CALCULATION CHANGE NOTICE

CHANGE NOTICE NO. 001

CALCULATION IDENTIFICATION NUMBER			
J.O. No.	DIV/GROUP	CALC. NO.	REV. NO.
16345	IC(B)	071	2
APPROVALS - SIGNATURE & DATE			
PREPARER(S)/DATE(S)	REVIEWER(S)/DATE(S)	INDEPENDENT REVIEWER(S)/DATE(S)	Confirmation Required (✓)
W R POWER W R Power 1/22/90	J. DACHANAY 1/23/90 William T. Dacanay	William E. Mankie William E. Mankie 1-23-90	<input type="checkbox"/> Yes <input checked="" type="checkbox"/> No

CLIENT & PROJECT TU ELECTRIC/COMANCHE PEAK STEAM ELECTRIC STATION				PAGE 1 OF 23 TOTAL NO OF PAGES: 23	
CALCULATION TITLE (Indicative of the Objective): CALCULATION OF ERROR IN ACCURACY FOR INSTRUMENTS INSIDE CONTAINMENT DUE TO LOW CABLE INSULATION RESISTANCE DURING MSLB OR LOCA				DESIGN DOCUMENT CLASSIFICATION 38 <input checked="" type="checkbox"/> Class I <input type="checkbox"/> Class II <input type="checkbox"/> Non-Safety	
CALCULATION IDENTIFICATION NUMBER					
JO OR WO NO.	DIVISION & GROUP	CURRENT CALC. CO.	OPTIONAL TASK CODE	DESIGN VALIDATION PACK WORK PACKAGE NO.	
16345	IC(B)	071	N/A	15J 15A REV 1	
APPROVALS - SIGNATURE & DATE			REV. NO. OR NEW CALC. NO.	SUPPLEMENTS/ SUPERCEDES CALC./REV NO	CONFIRMATION REQUIRED (YES/NO)
PREPARE

VII. EFFECT OF DECREASED "IR" ON HTTC SIGNALS

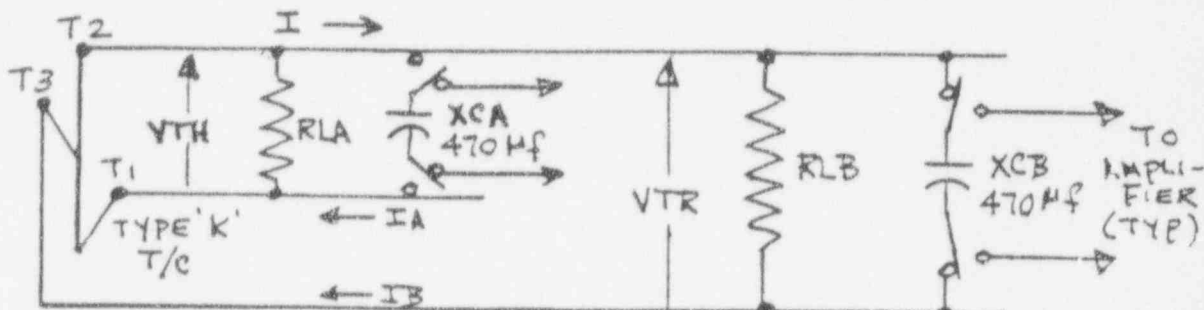
6. On Calculation Page 23:

A. add to (Ref. 12):
(Book 1, section 802,
subsection 3-1)

B. add the following statement
to bottom of page:

CALCULATED IR = 0.98×100 Megohms for 10 FT
SAMPLE (REF. 13). THIS IS EQUIVALENT TO
980 MOHMS PER FOOT. FOR CONSERVATISM WILL
USE 23.8 M Ω /L (FOR HTTC CABLES ON PG 22)
